i-Pilot Link Remote “Invalid Software” Recovery

Affected Models: All i-Pilot Link BT Equipped Motors (Ulterra, Terrova, Ultrex).

Reason: Process Change, Correction to Case XI of the i-Pilot Link repair manual.

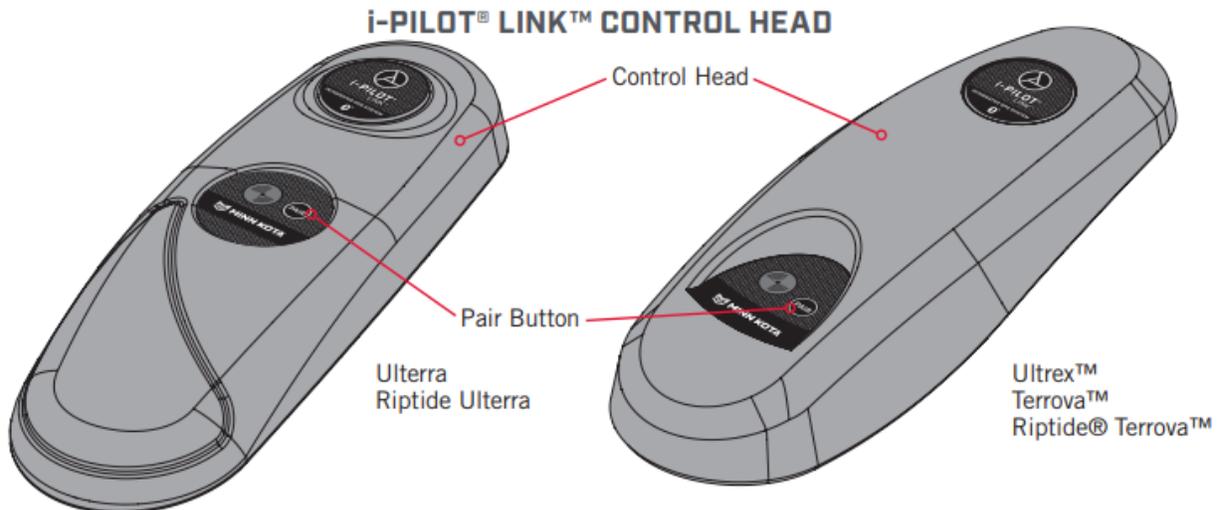
Cause 2: Current software on the remote is unreadable. This will show the Current Software “INVALID”, as in the picture to the right.

Corrective Action 2: Reload/Update Remote Software following these instructions.

Step 1. Update the i-Pilot Link Software. It is important to have the latest software in the motor to avoid any potential issues when the update is completed.

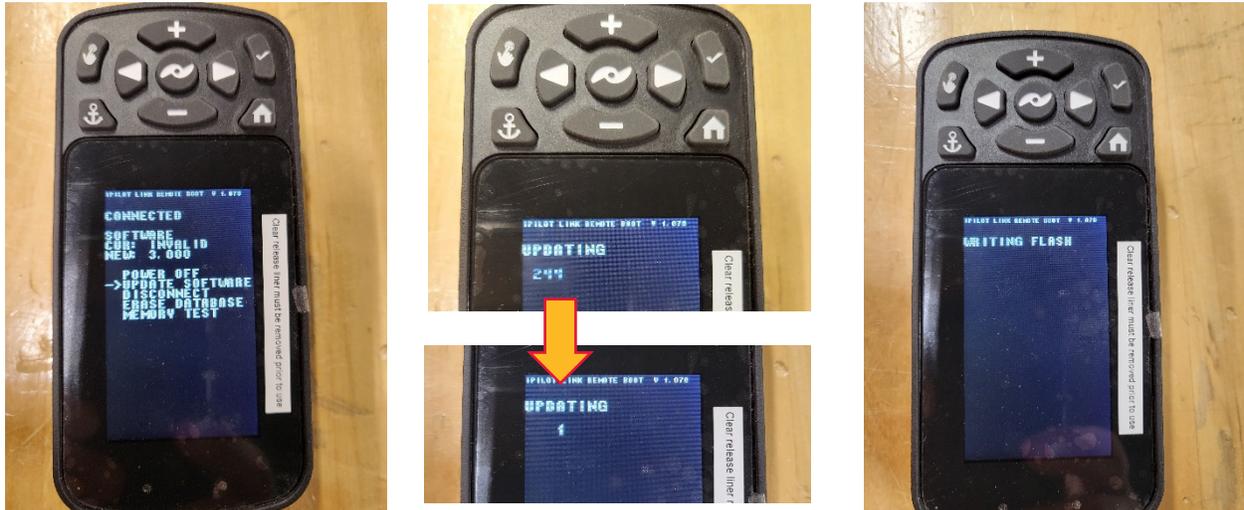
Step 3. Press and hold the “Pair” button on the i-Pilot Link Control Head of the motor (the motor will emit a continuous tone while you hold the pair button). Do not release the button through the end of Step 4.

Step 4. Scroll down from “POWER OFF” to “Pair” using the “-” button on the keypad. Press the “✓” on the remote. The remote will say “PAIRING” while scanning for the motor, when the motor successfully pairs to the remote the motor will emit three beeps and the tone will stop, and the top of the text screen will now say “CONNECTED”. You can release the Pair button on the control head at this point.
